Category K (05)	Applicable Model/s 1995-98 Millenia	Subject ATF LEAK / ABNORMAL SHIFTING / SHIFT SHOCK	Bulletin No. 013/98
			Issued 11/04/98
			Revised

DESCRIPTION

ROUTE SEALANT AROUND
THE INSIDE OF THE BOLT HOLES

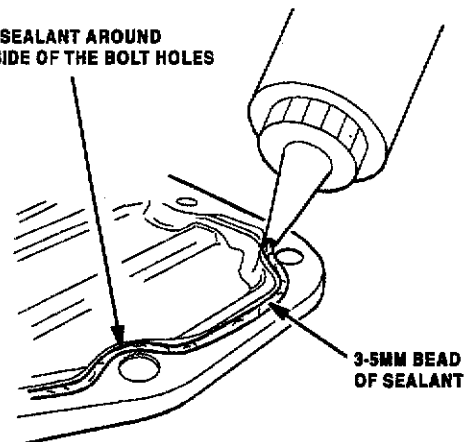
6. Apply a continuous 3-5mm {0.12-0.19 in} bead of sealant along the contact surface and around the bolt holes as shown.

- Applying more sealant than recommended, may cause sealant to spill over into the oil pan.

APPLY SEALANT ON TOP OF OIL PAN GASKET ALSO

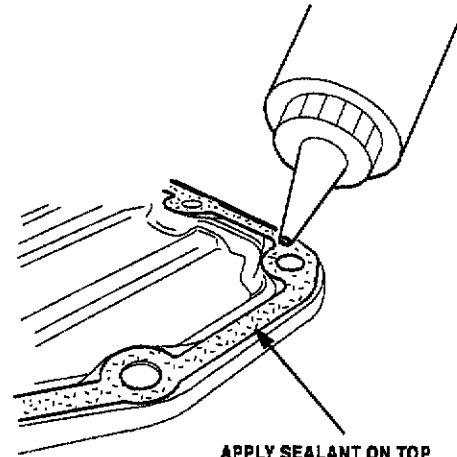
7. Align and place the pan gasket in position.
8. Apply sealant to the oil pan gasket in the same way as Step 6.
9. Install oil pan and tighten new bolts gradually and evenly.

Tightening torque
6.9 - 8.8 Nm (70-90 kgf-cm, 61-78 in.-lb.)
